ENSTROM HELICOPTER CORPORATION

SERVICE DIRECTIVE BULLETIN

SERVICE DIRECTIVE BULLETIN 0052
Attachment - Bendix Service Bulletin No. 614

Subject: Repair of Five Wire Connector

Figure 1 Defect

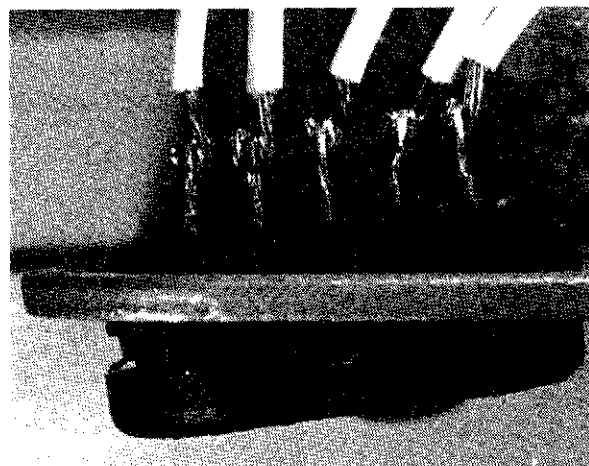
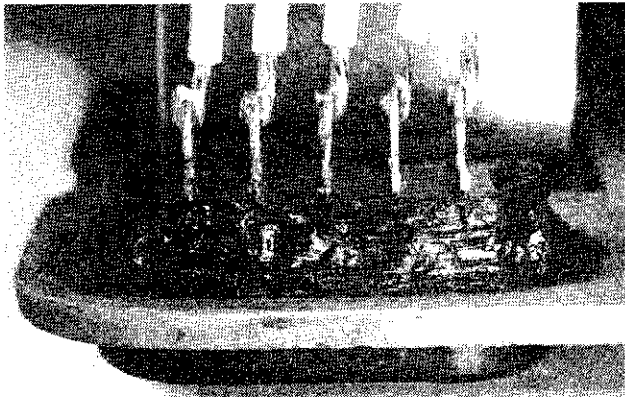
Bushing (connector), P/N 10-382943, may become loose in the vibrator plate and cause the grounding of both magnetos with possible loss of ignition. See figure 1 (defect).

1. Remove starting vibrator from the airframe.
2. Remove cover to expose the internal surface of the terminal bushing (connector).
3. The surface around the terminal bushing must be clean, dry, free of oil, dirt and grease.
4. Reseat the terminal bushing in the mounting plate to its full extent.

5. Use RTV (Silicone rubber sealant, or equivalent, Dow Corning Corp., Midland, Mich. 48640) to seal terminal bushing to the mounting plate. Apply a small bead completely around the bottom of bushing to secure the bushing to the plate as shown in figure 2 (repaired). If RTV is not available, use either Hysol, Epoxi-Patch Kit (general purpose), Hysol Corp., Olean, NY or Conap, Easy epoxy Kit (K20 general purpose) 1405 Buffalo St., Olean, NY, or equivalent.
